Phillips Planning Services Ltd.

16th January 2017

Revised Plans-Planning Application 2016/2457/P at 1-3 and 4, 6, and 8 Ferdinand Place, London

OS plan extract showing the application sites in relation to Nos 4 - 6 Collard Place

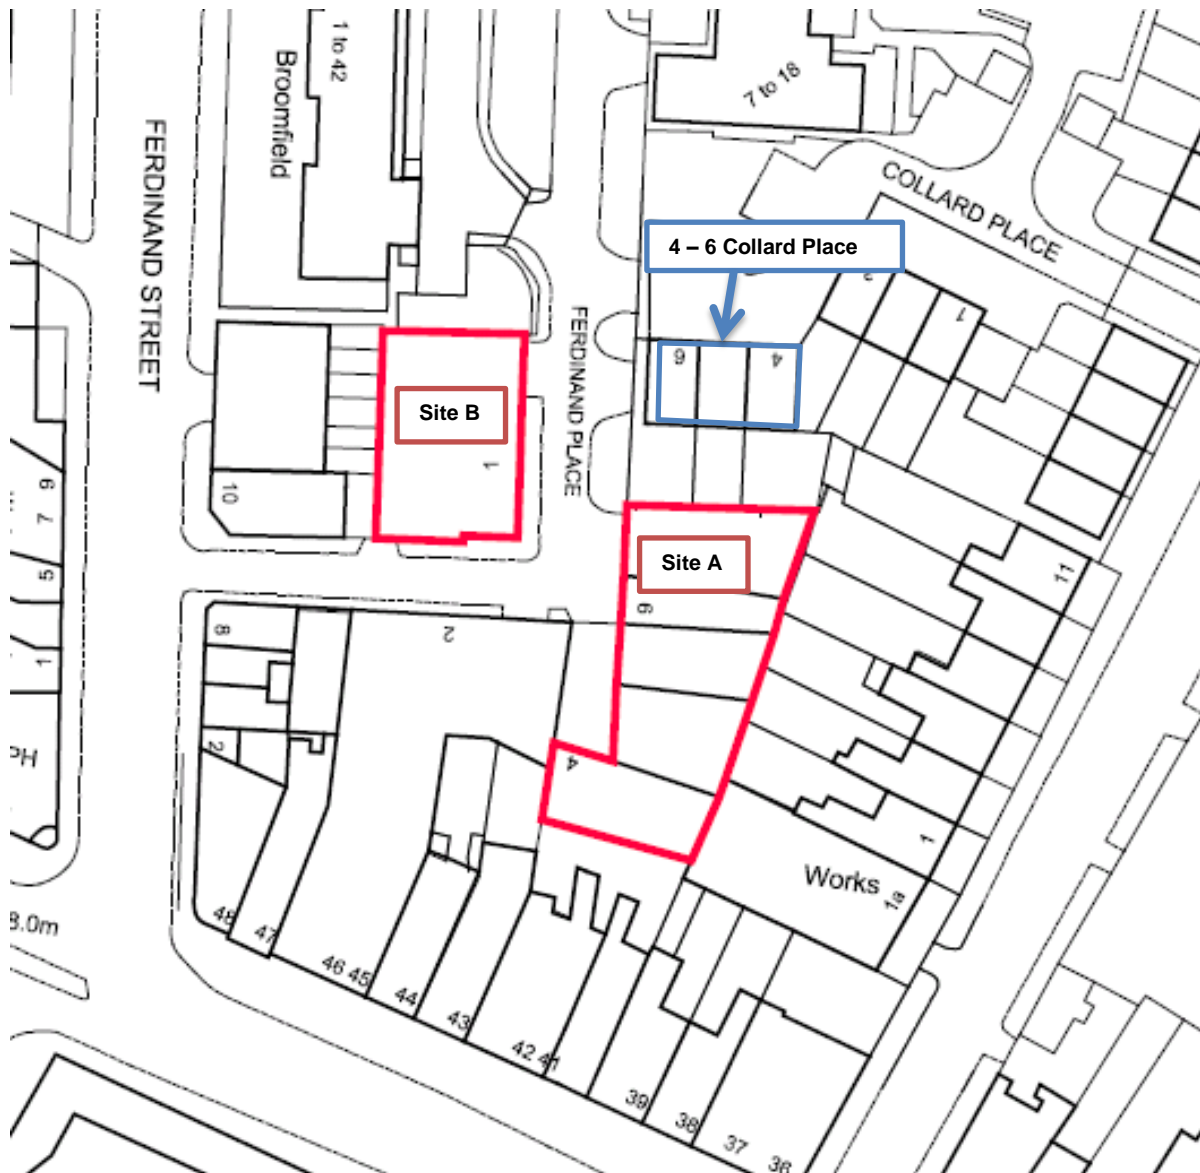
No. 4 Collard Place is a three storey dwelling and forms part of a small terrace of three dwellings (Nos. 4, 5 and 6) located directly to the north of 'Site A' and to the east of 'Site B' of the application site.

The rear of the properties face south meaning that the windows on the southern elevation (which serve habitable rooms) and the rear gardens adjoin and look directly out onto 'Site A' (4-8 Ferdinand Place), whilst the side elevation of the terrace faces 'Site B' The side of No. 6 contains a second floor window.

As is apparent the gardens of the Collard Place properties are quite short, so the backs of the houses are approximately 6 - 7 metres from the boundary with Site A.

View from the rear of No.4 Collard Place showing flat roof and part of pitched roof

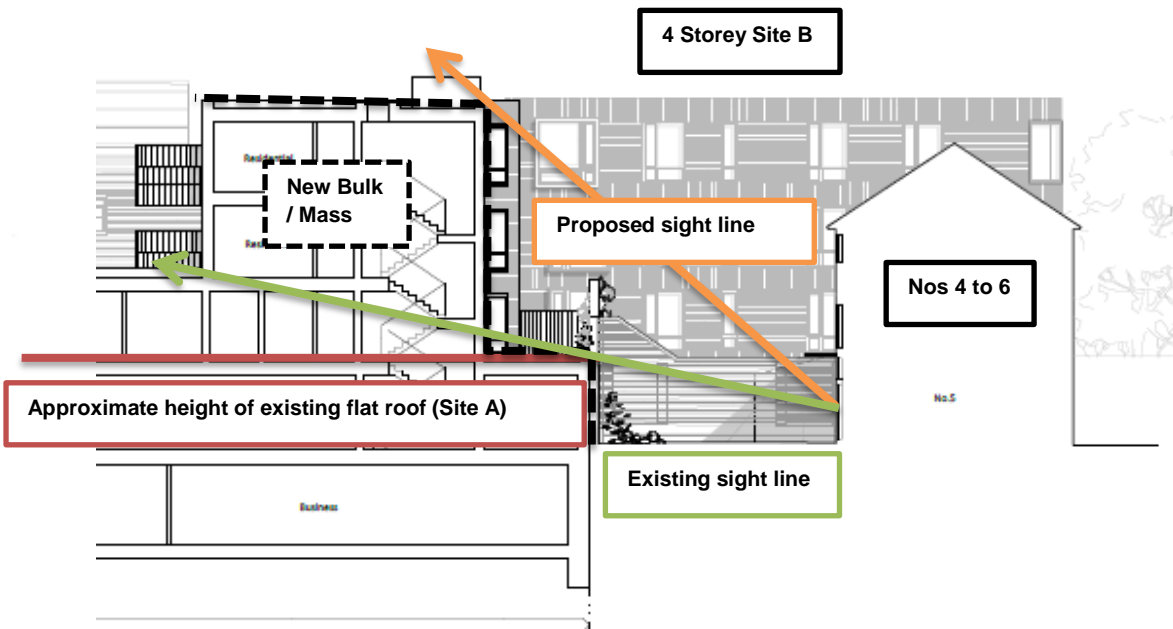
At the present time however the relationship whilst not ideal is not materially harmful due to the scale of the building that occupies site A. This is single storey with a flat roof where it adjoins the rear garden of No. 4 rising to a pitch (although still single storey) behind Nos 5 and 6.

The first of the photographs below shows a view from the rear first floor window of No. 4. The second shows a view looking across the rear gardens of 5 and 6 toward the pitched roof section of the existing building.

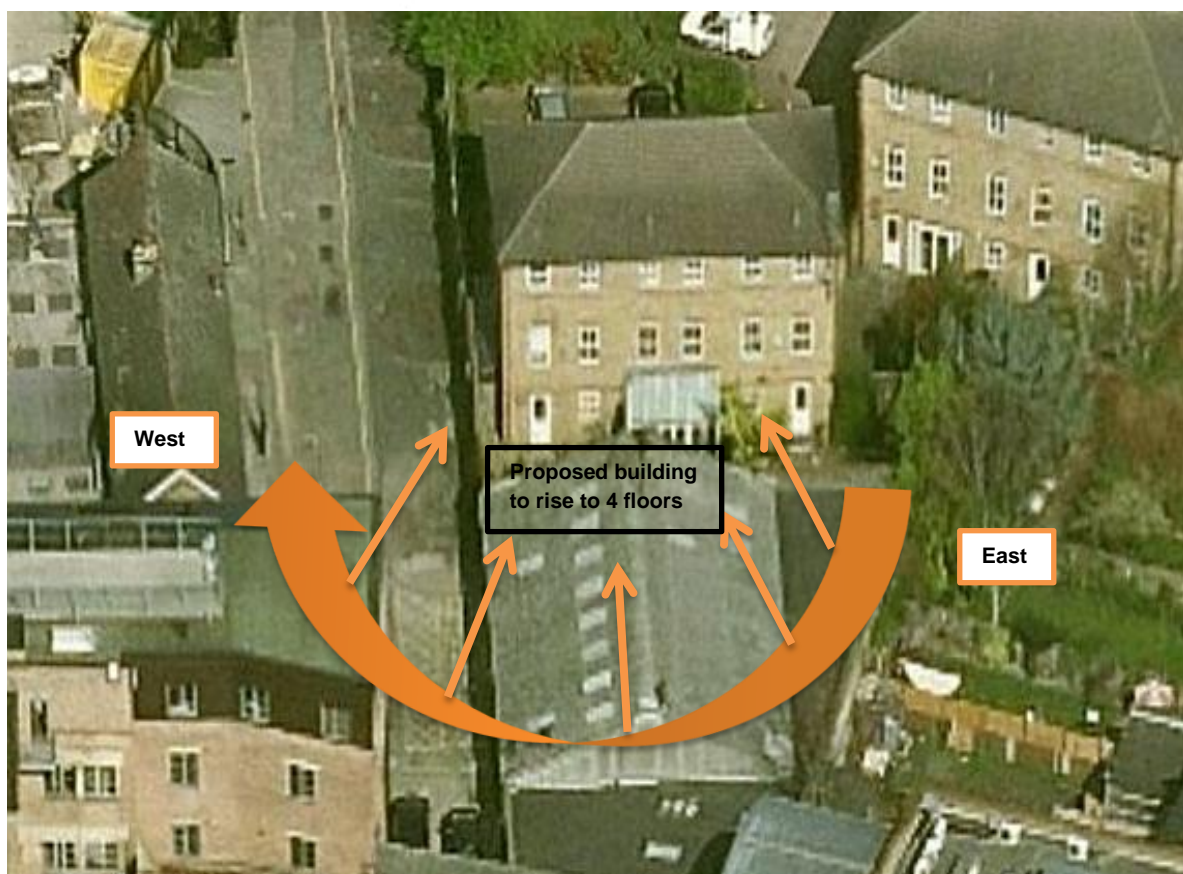
Although the revised report contains no analysis, it is clear from comparing the daylight/sunlight figures to the original report that the revised proposals do little to improve the detrimental impact which they would cause.

As previously highlighted, the level of daylight 4-6 Collard Place receives is exceptionally high for an urban location (Vertical Sky Components-close to 40%), and the erection of the revised proposals, would continue to result in the levels of daylight less than the BRE recommendation (VSC 27%).

As will be noted, the revised figures demonstrate that a harmful reduction in daylight would result from this development and this is contrary to Council policy.
